Re: Docket Nos. E-2, Sub 1318, EC-67, Sub 55 – Joint Application of Duke Energy Progress, LLC, and North Carolina Electric Membership Corporation for a Certificate of Public Convenience and Necessity to Construct a 1,360 MW Natural Gas-Fueled Combined Cycle Electric Generating Facility in Person County, North Carolina

DOCKET NO. E-2, SUB 1318  
DOCKET NO. EC-67, SUB 55

**JOINT TESTIMONY OF  
EVAN D. LAWRENCE AND  
DUSTIN R. METZ  
PUBLIC STAFF –  
NORTH CAROLINA  
UTILITIES COMMISSION**

5 Figure 1: Proposed PSNC pipeline routing map.

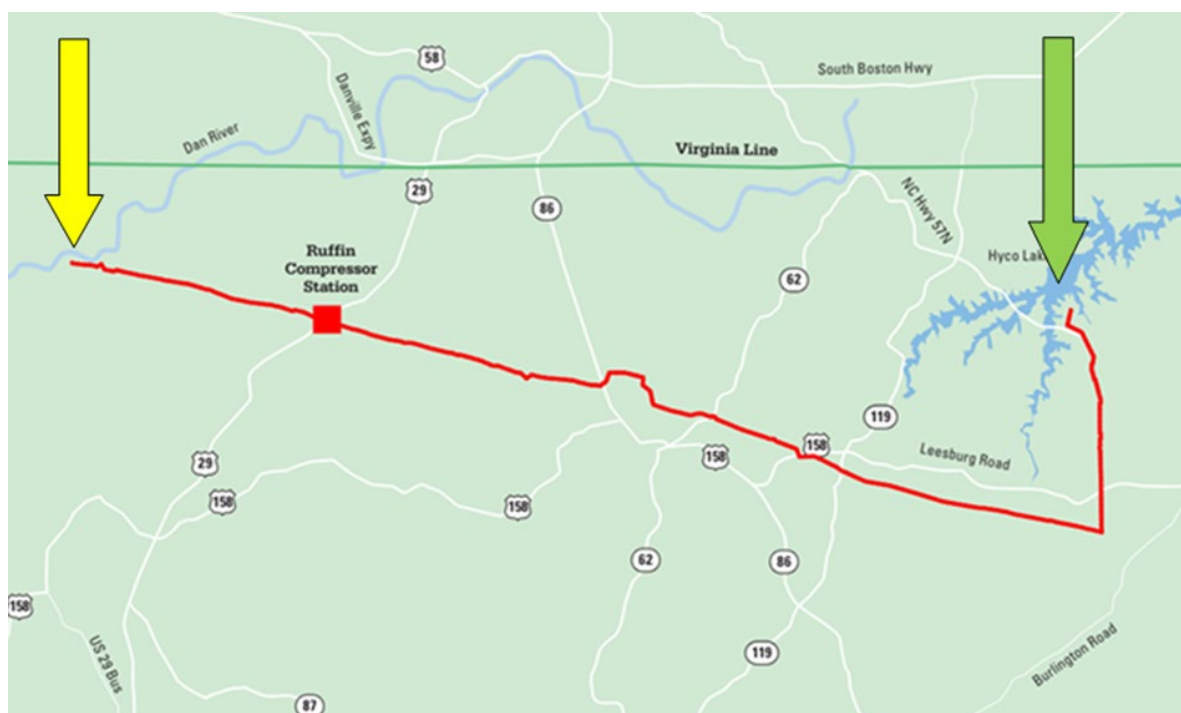
21 The routing of the proposed PSNC pipeline is shown in Figure 1,  
22 below, and is represented by the red line. At far left (near the Dan

1 River), the yellow arrow indicates the proposed PSNC intertie with  
2 Transco. The green arrow at the right northerly portion of the red line  
3 that terminates near Hyco Lake shows the offtake point for the  
4 Roxboro proposed facility.

1 Figure 5: Person County CC site layout with second CC

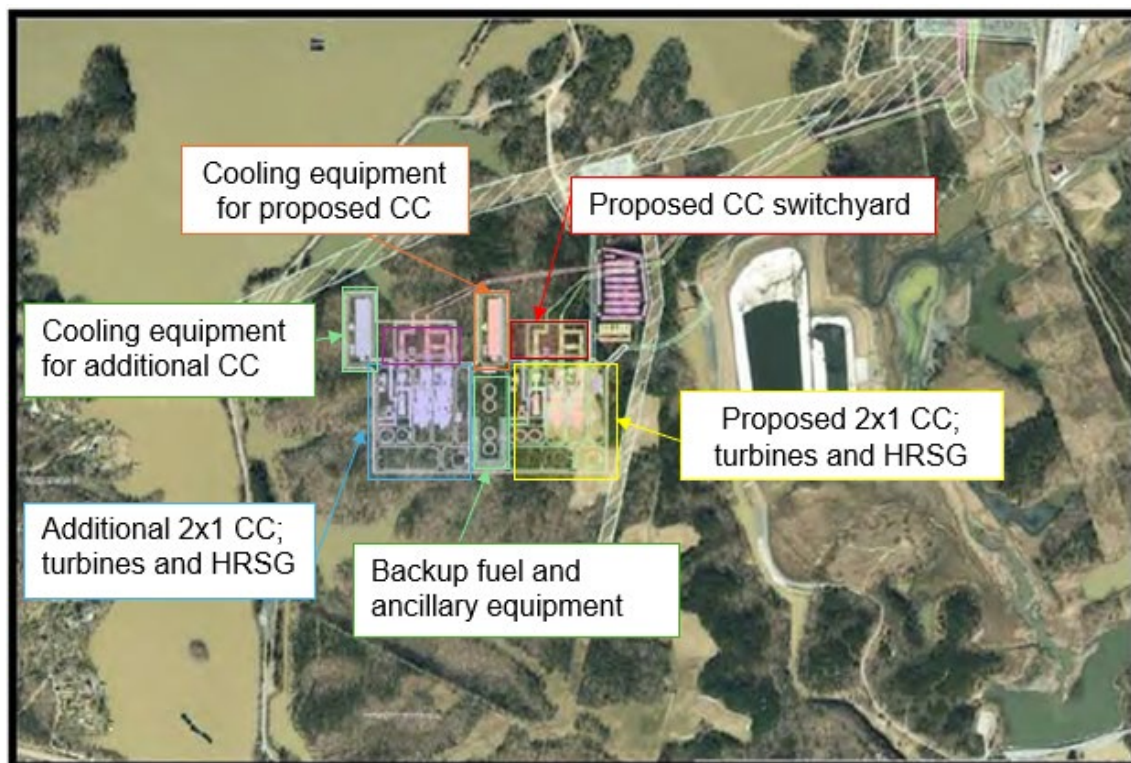
5 A. As shown on page 270 of Exhibit 2 of the Application, the response to  
6 PSDR 6-1, and other discovery responses, it appears that the  
7 Company intends to build two CCs at Roxboro as identified below in  
8 Figure 5. A proposed 2x1 CC (CC1) is outlined in yellow and the  
9 additional 2x1 CC (CC2) is outlined in blue. We modified this figure  
10 from the one included in the Application by adding the labels and  
11 colored boxes.

- 3 **Q. Will a second CC require additional natural gas pipeline**  
 4 **upgrades?**
- 5 A. Yes. The total PSNC pipeline costs to provide service to CC1 and CC2  
 6 at Roxboro are estimated to be approximately **[BEGIN**  
 7 **CONFIDENTIAL]** [REDACTED] **[END CONFIDENTIAL]**, or an incremental  
 8 amount of approximately **[BEGIN CONFIDENTIAL]** [REDACTED] **[END**  
 9 **CONFIDENTIAL]**, beyond the pipeline costs projected to provide  
 10 service to CC1.
